Proposed Revisions to a Standard Plans Index
(Please provide all information – Incomplete forms will be returned)

Index Number: 536-002
Sheet Number (s): Sheets 3,4
Index Title: Guardrail Transitions and Connections for Existing Bridges

GUARDRAIL TRANSITIONS AND
 CONNECTIONS FOR EXISTING BRIDGES

INDEX
 536-002

SHEET
 3 of 27

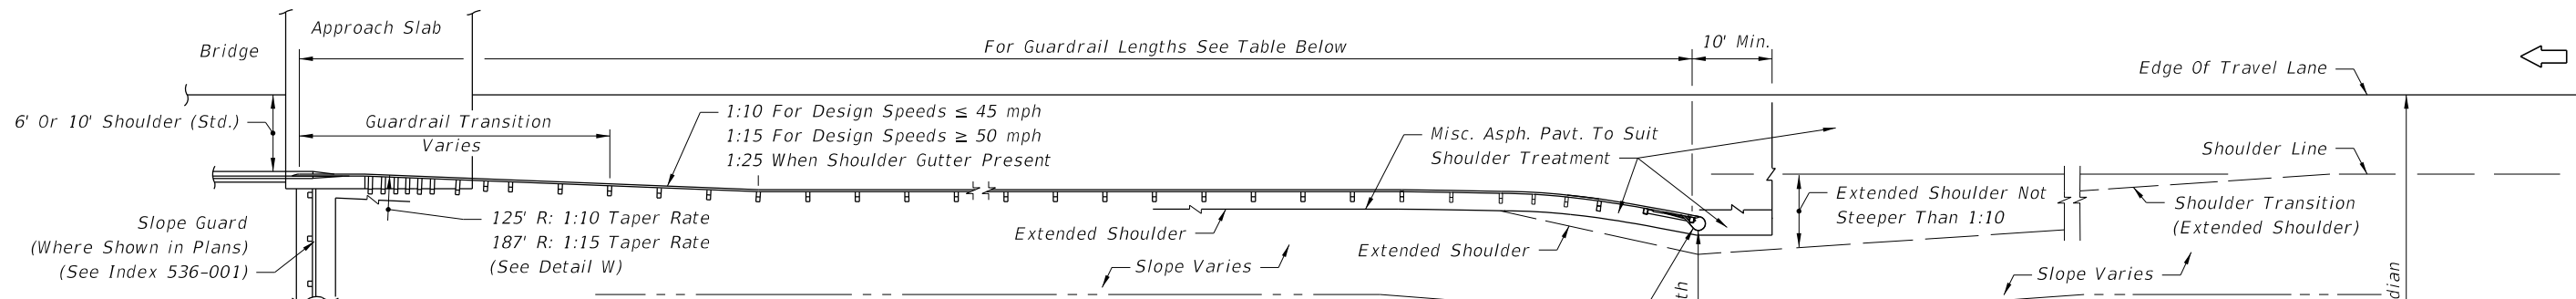
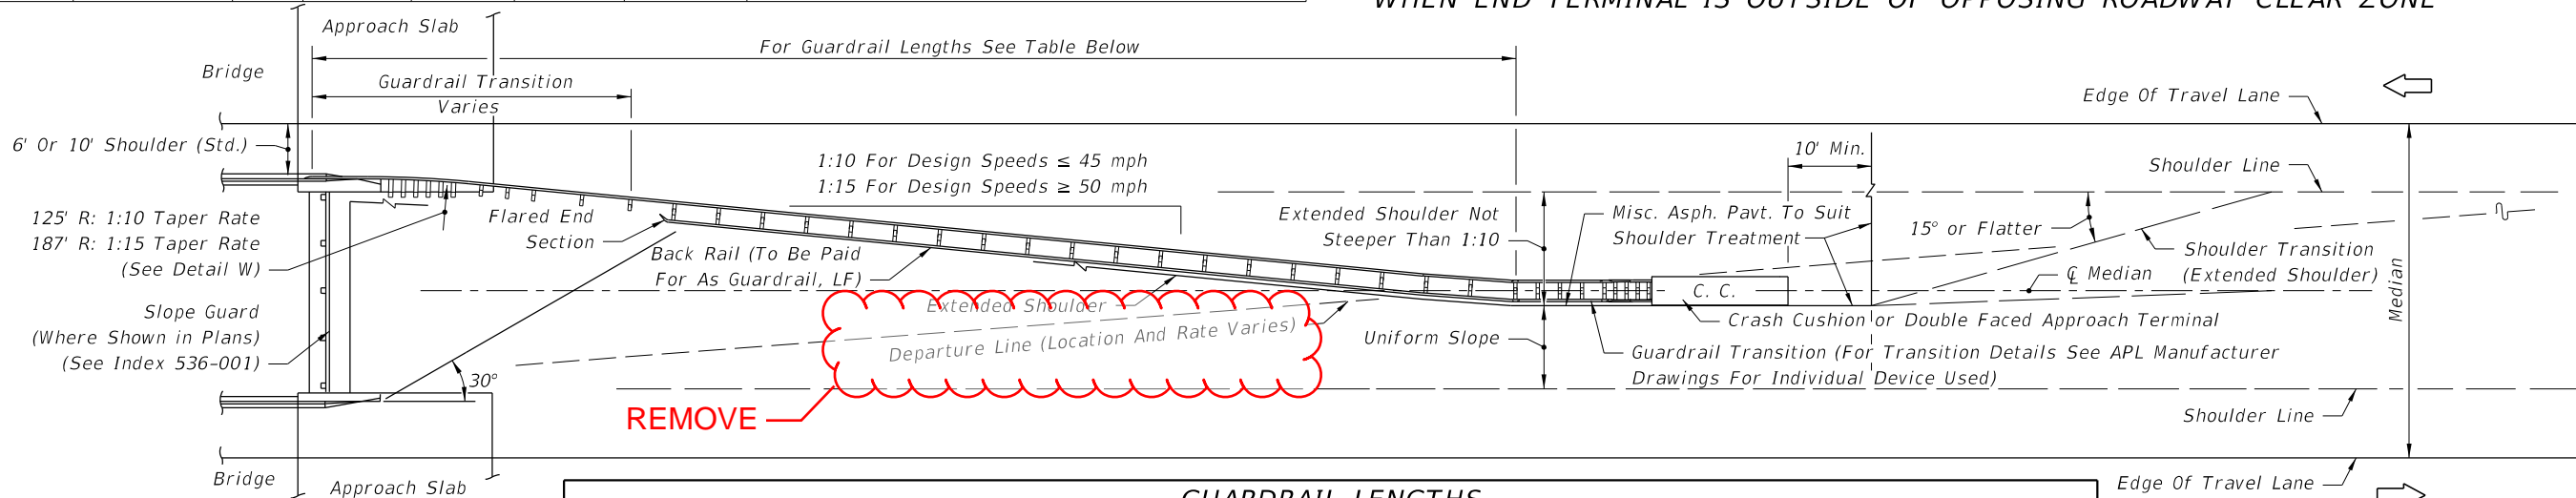
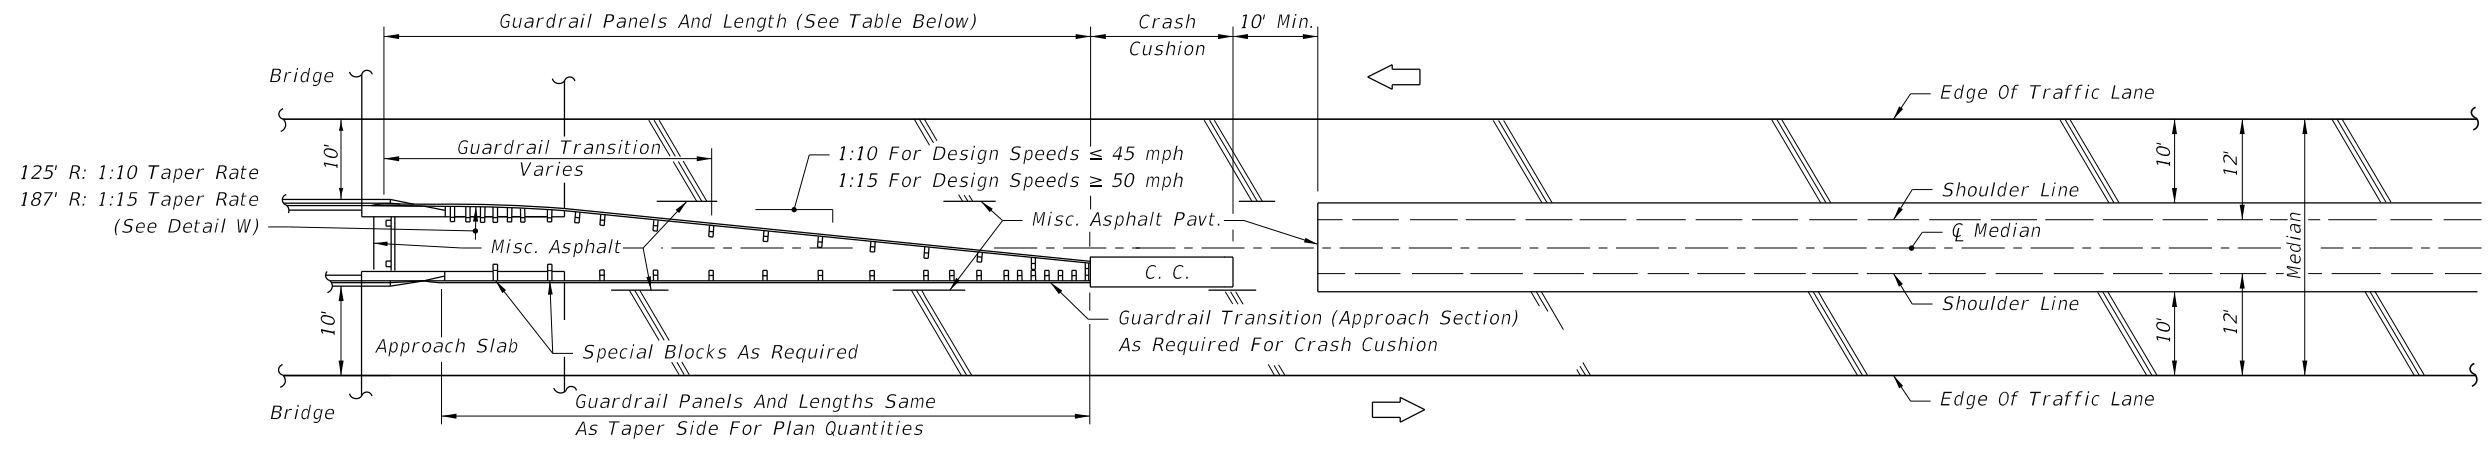
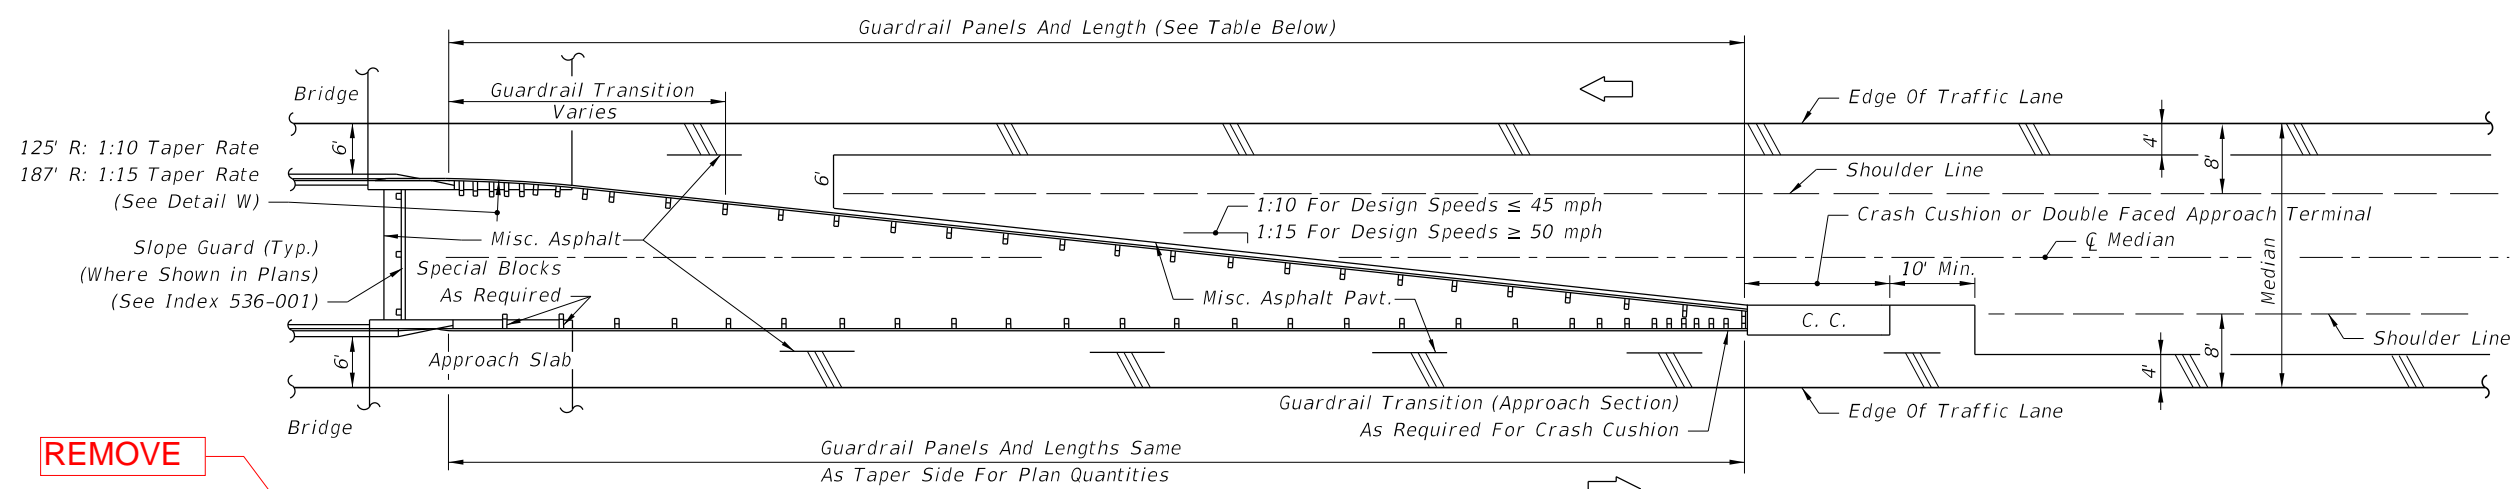
Sheet 3: Remove Departure Line
Sheet 4: Remove Crash Cushion sizing information. Unless otherwise shown in the Plans, there is no sizing limitation on contractor selection.

Crash Cushions, Index 544-001 has been redeveloped with a new length of need departure line assumption. As part of the Crash Cushion updates, outdated information in Index 536-002 is being removed.

INDEX	SHEET
536-002	4 of 27

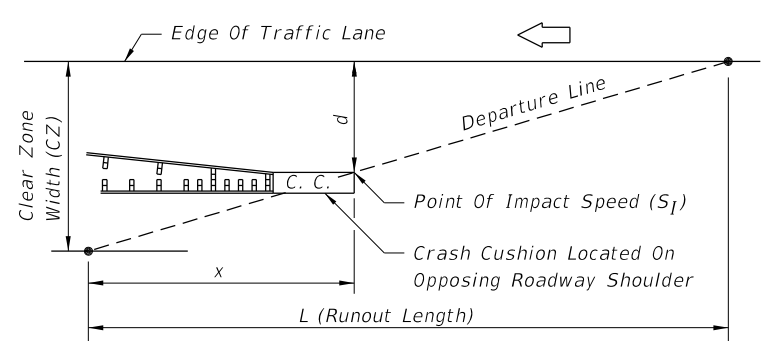
REMOVE

The lengths shown in this table are based on standard widths for roadway and bridge median shoulders. Length requirements for both standard width and narrow bridge shoulders and end anchorage or end shielding requirements shall be determined on a site specific basis. ~~When crash cushions are required on opposing roadway shoulders, their sizes may be determined by the residual speeds (S_1 's) along the runouts from the approach roadways; however, when calculated speeds (S_1 's) are less than 30 mph crash cushions shall be no less in size than for 30 mph; see speed diagram left. The number of panels may be reduced when installing a crash cushion more than 2.5' in width; see * below.~~
